# **The Lake Lothing (Lowestoft) Third Crossing Order 201[\*]**

**Impact of the Scheme on the Port of  
Lowestoft  
Document SCC/LLTC/EX/59**

Author: Suffolk County Council

Date: January 2019

Figure 5 - Location of Scheme with reference to existing berth provision (republished from Annex 6 of ABP's Written Representation)

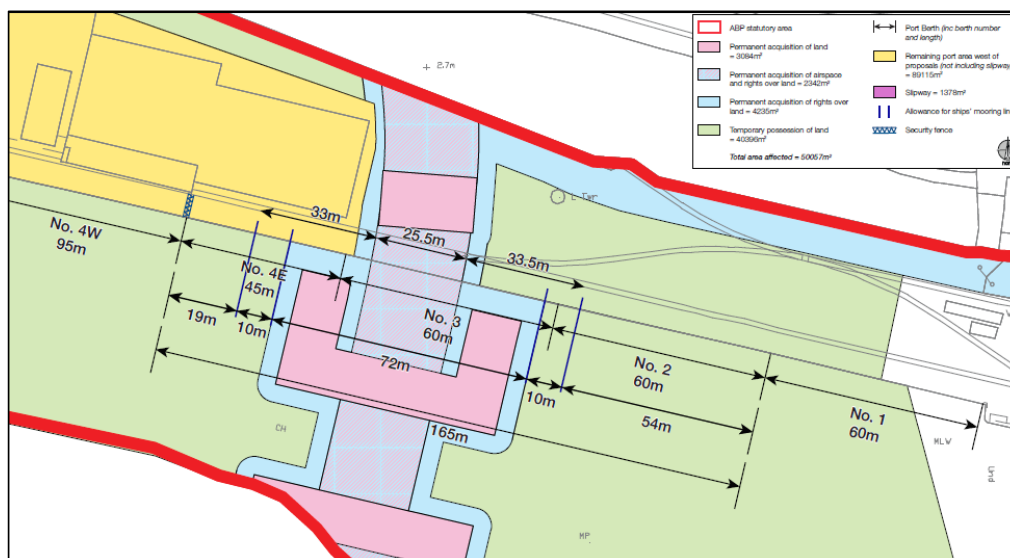
**Comment [MS68]:** What does 'generally' mean in this context? To assist the ExA, the Applicant needs to be more specific in its position.

Figure 6 - Alternate mooring arrangement

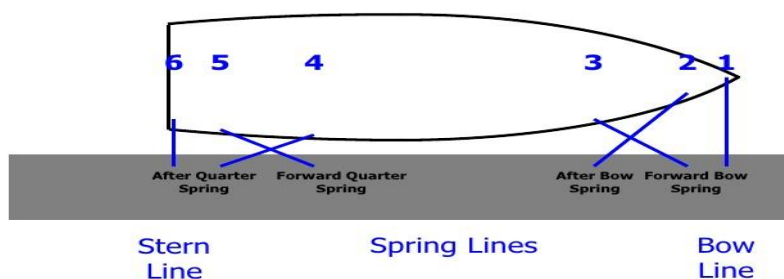
**Comment [MS69]:** Without a consideration of bollard positions, this analysis is incomplete and therefore of limited use to the ExA. ABP has now supplied bollard positions to the hearing. Suggest the Applicant reconsiders this entire section in light of this.

**Comment [MS70]:** Is the Applicant still intending to advance this as a serious in light of ABP's evidence from multiple east coast ports that this is not a practice in use in tidal locations.
